*Preliminary Consultation*  
**MONTGOMERY COUNTY HISTORIC PRESERVATION COMMISSION**  
**STAFF REPORT**

<b>Address:</b>	13 East Melrose St., Chevy Chase	<b>Meeting Date:</b>	3/27/2019
<b>Resource:</b>	<b>Contributing Resource</b> Chevy Chase Village Historic District	<b>Report Date:</b>	3/20/2019
<b>Applicant:</b>	Thomas O'Donnell and Caroline Fawcett (Vince Greene, Architect)	<b>Public Notice:</b>	3/13/2019
<b>Review:</b>	Preliminary Consultation	<b>Tax Credit:</b>	N/A
<b>Case Number:</b>	N/A	<b>Staff:</b>	Michael Kyne
<b>PROPOSAL:</b>	Partial demolition and construction of a new rear addition; driveway replacement.

PROJECT NAME:	DRAWING TITLE:	© 2019 GREENEARCH	DATE:	DRAWING #:
FAWCETT/O'DONNELL RESIDENCE 13 E. MELROSE STREET CHEVY CHASE, MARYLAND 20815	EXISTING/PROPOSED REAR ELEVATION (NORTH)	SCALE: 1/8" = 1'-0"	CREATED: 01/16/2019	A-202 18
			REVISED: 03/06/2019

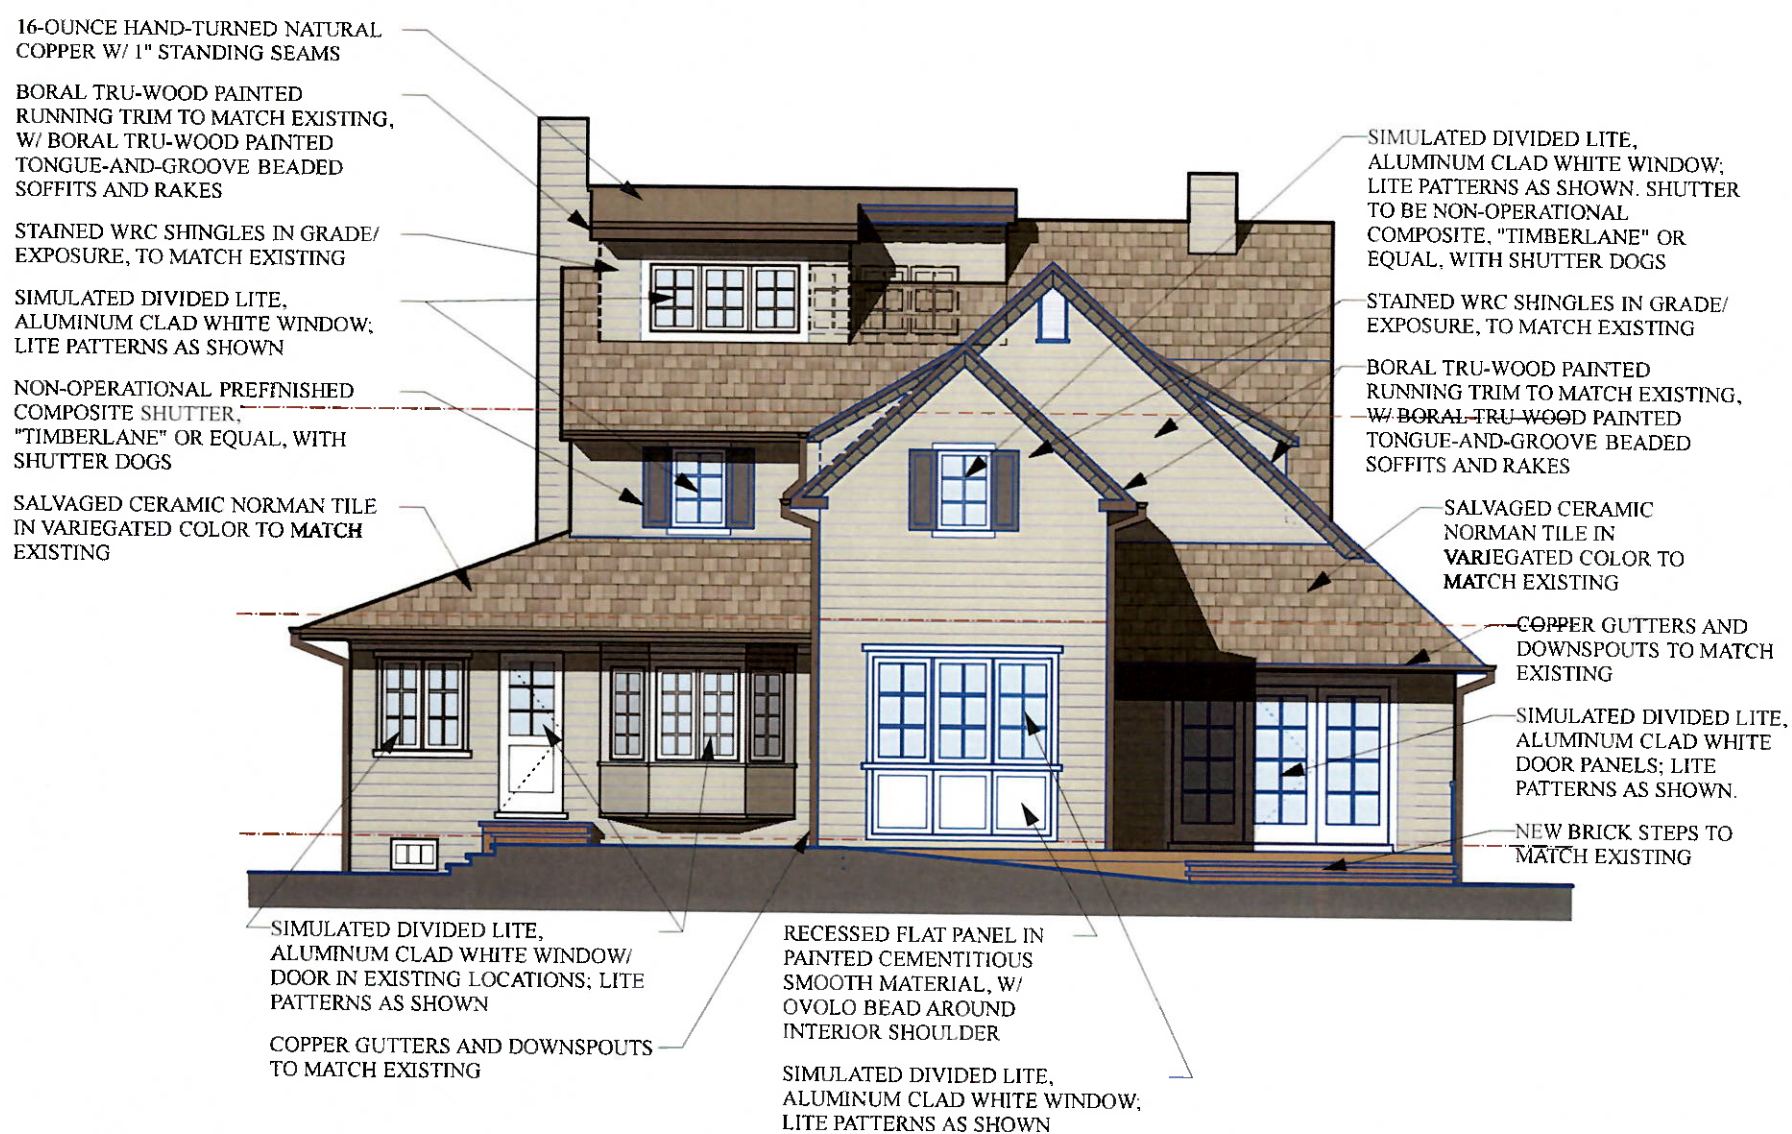
- The proposed addition will project beyond the west side of the historic house and be clearly visible from the public right-of-way, where it has the potential to detract from the streetscape. While, in some respects this is an existing condition, staff finds that is an incompatible alteration that would not be approved as part of an entirely new rear addition.

- The proposed addition will introduce various complex roof forms to the structure, which are incompatible with the character of the historic house.
- Removing the westernmost portion of the existing shed dormer results in an atypical condition at the ridge of the historic house.

- Regarding materials, the applicants propose to use compatible materials (i.e., shingle tile and standing seam copper roofing, cedar shingle siding, and aluminum-clad SDL casement windows to replace existing non-historic casement windows with snap-in grilles), but staff is concerned about the compatibility of the proposed windows and doors with the style of the historic house.

- Should the applicants explore alternatives that do not project beyond the west side of the historic house?
- Should the applicants explore alternatives with less complex roof forms?
- Should the applicants explore alternatives that do not require the existing shed dormer to be altered and/or partially removed?
- Should the applicants explore alternative windows and doors with a more compatible number and/or pattern of lites?
